Design Change of Transceivers for Wireless Positioning Units "EPC-200-CC"

Transceivers for Wireless Positioning Units - PLC Control / CC-Link[®] Compliant "EPC-200-CC" will be changed as follows. Pricing will not differ as a result of this modification.

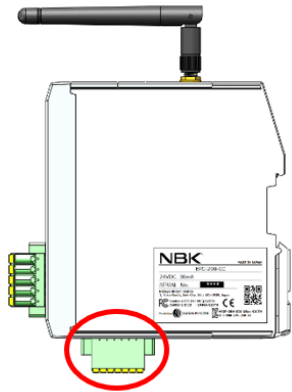
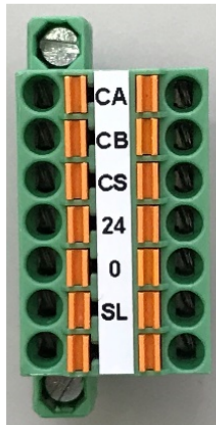
The protrusion dimension will be smaller due to the change in the connector.

Before Change	After Change
Connector's Protrusion Dimensions	(20.8)	(16.5)
External Dimensions	<p>Unit: mm</p>	<p>Unit: mm</p>
